ENVIRONMENTAL IMPACT REPORT

Project No. 212995 SCH No. 2010101030

HILLEL CENTER FOR JEWISH LIFE: SITE DEVELOPMENT PERMIT and a PUBLIC RIGHT-OF-WAY VACATION to allow the applicant to develop the Hillel Center for Jewish Life (HCJL) to provide religious programs for Jewish students at the University of California San Diego (UCSD), including meetings, one-on-one counseling, and administrative offices. Hillel currently uses a residential structure located at 8976 Cliffridge Avenue (Cliffridge property) to provide these religious programs. The vacant site is located at the southwest corner of the intersection of La Jolla Village Drive and La Jolla Scenic Way, which is just south of UCSD. Hillel has identified a need for additional space to improve services and provide a full range of religious programs in a centralized location for Jewish students at the UCSD campus (the project cannot be located on land owned by UCSD due to church and state separation issues). Hillel proposes to develop the HCJL in two phases to provide additional space for religious programs in three buildings around a central courtyard, referred to as the Phase 1/Phase 2 project throughout the Environmental Impact

FIGURE 3-5
Phase 2 Ground Floor Building Plan

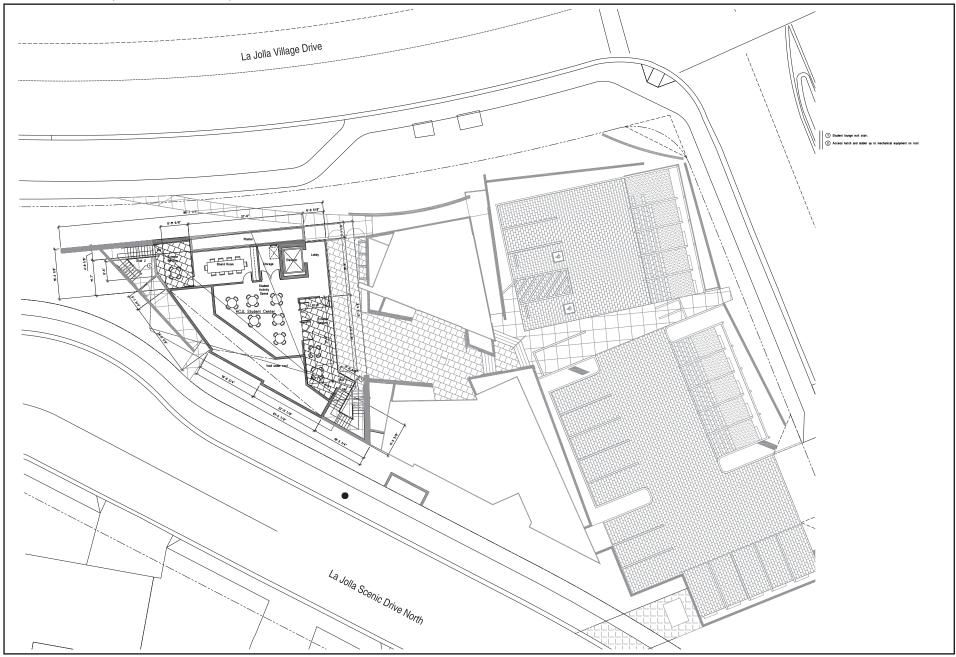
- I don't understand. Is the HCJL 3,682 square feet or 4,287 square feet?
- · Figure 3-5 is difficult to read. Please describe in more detail this building for example:

FIGURE 3-8

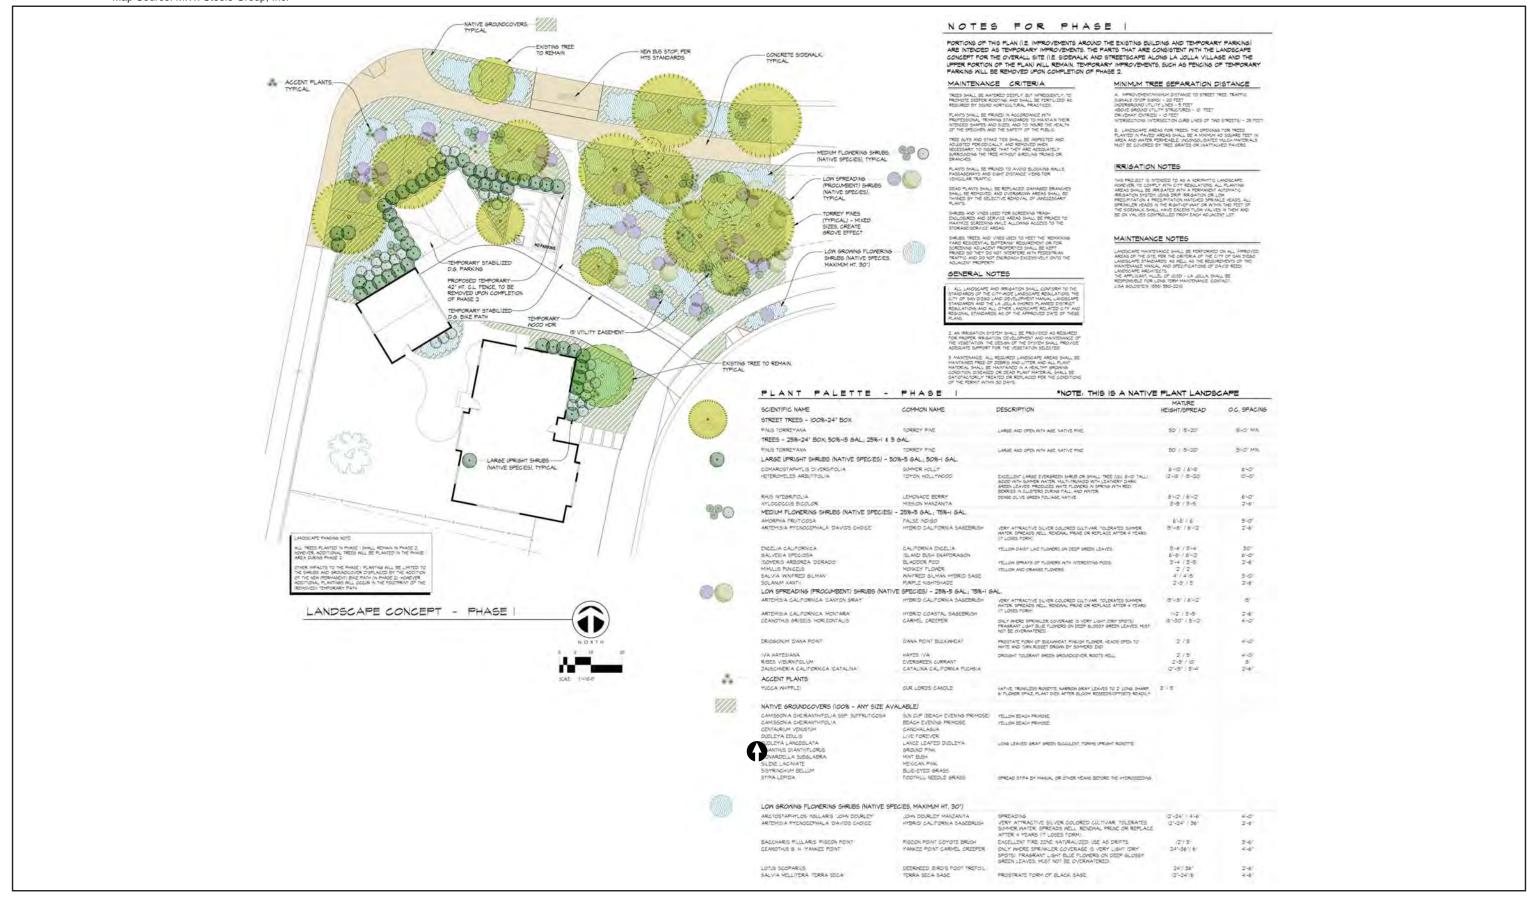
- Figure 3-8 is difficult to view details. The north parking lot appears to have 8 spaces (including 2 handicap spaces). The mid-lot appears to have 10 parking spaces. And the south parking lot appears to have 8 spaces. This only adds to 26 parking spaces. Where is the 27th space?

- AO-17 Please see the response to comment AO-16.
- AO-18 The EIR figures have been renumbered in the Recirculated EIR (December 2013). EIR. Please see updated Figure 3-5. There are 27 spaces depicted in this figure.
- AO-19 The construction of the project driveway on La Jolla Scenic Way would result in a loss of three parking spaces, an additional three parking spaces would be lost in order to meet stopping sight distance requirements; therefore, a total of six on-street parking spaces would be lost on La Jolla Scenic Way. The proposed street vacation of the La Jolla Scenic Drive (N) cul-de-sac would result in a net loss of six parking spaces.
